**RFP# 19-1004**  
Audio Visual Production and Management Services  
**Addendum 2**  
March 11, 2020

**Facility Capacity**

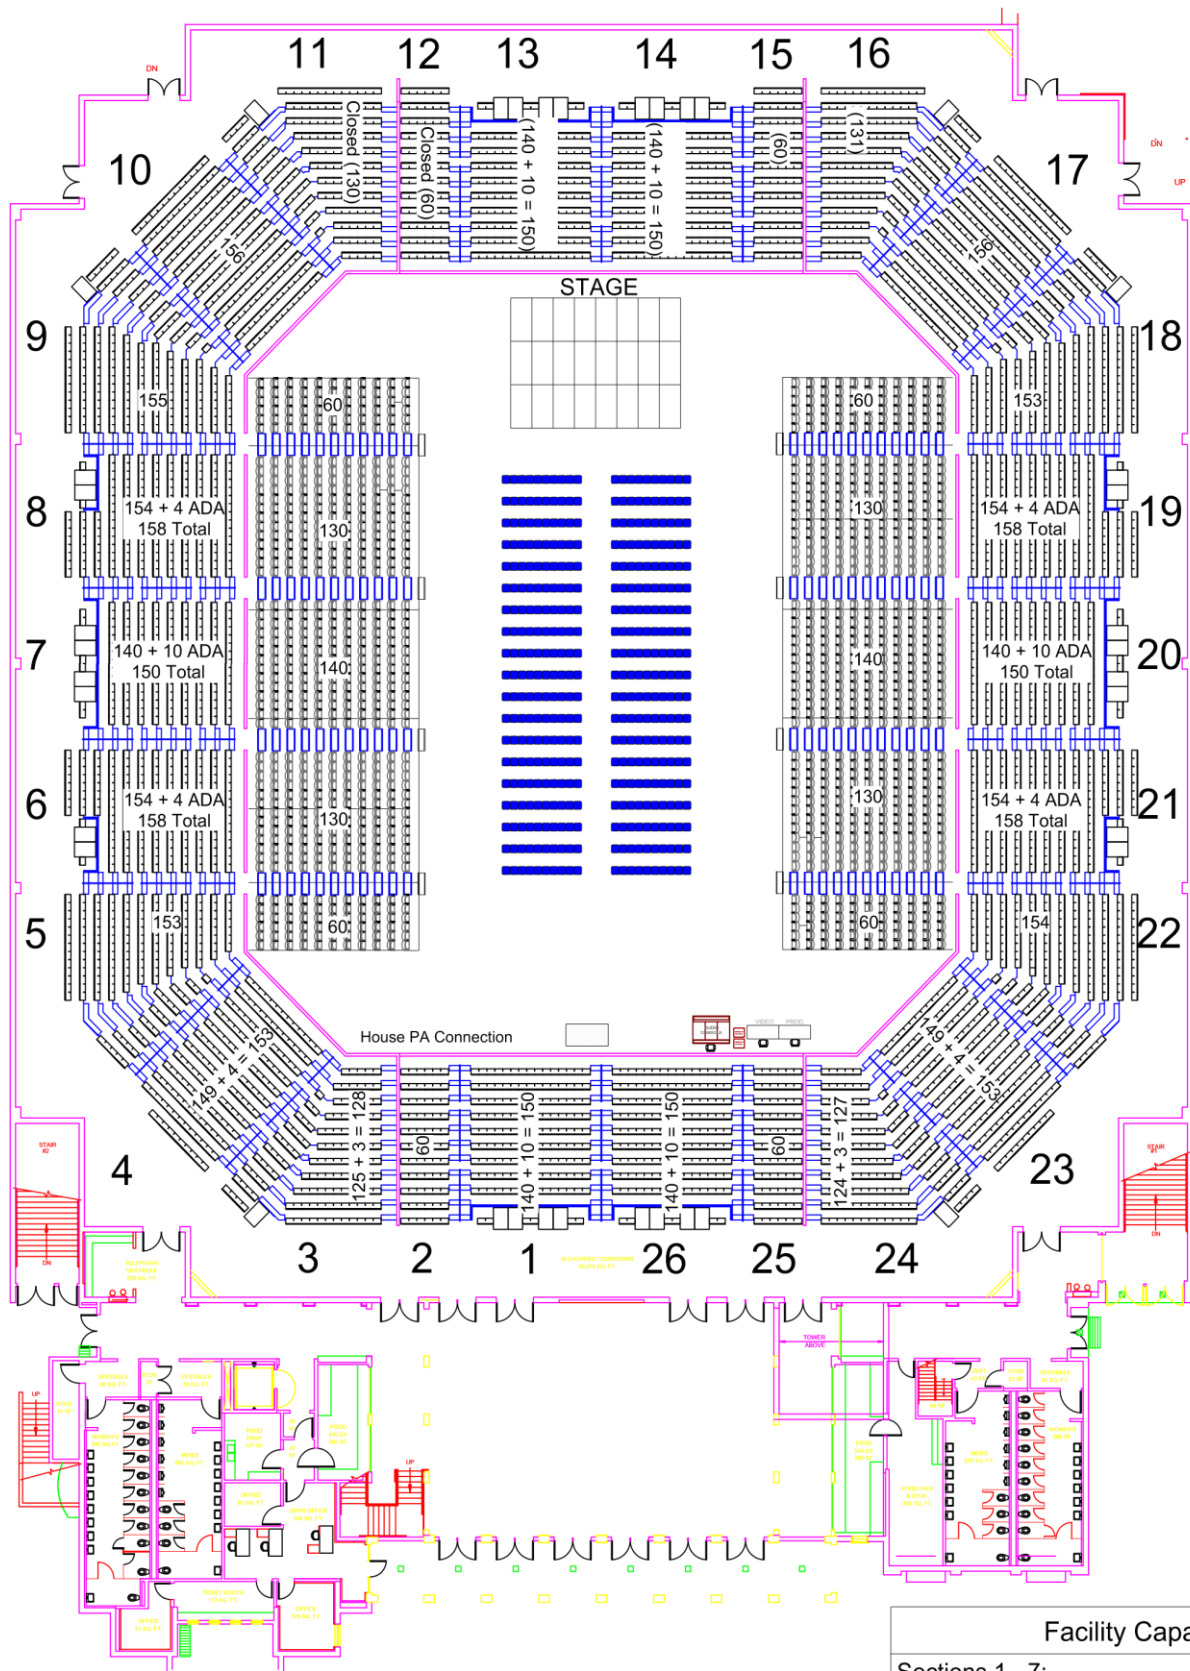
**Q. Do you have a diagram of the Jenny Craig Pavillion?**

A. Attached
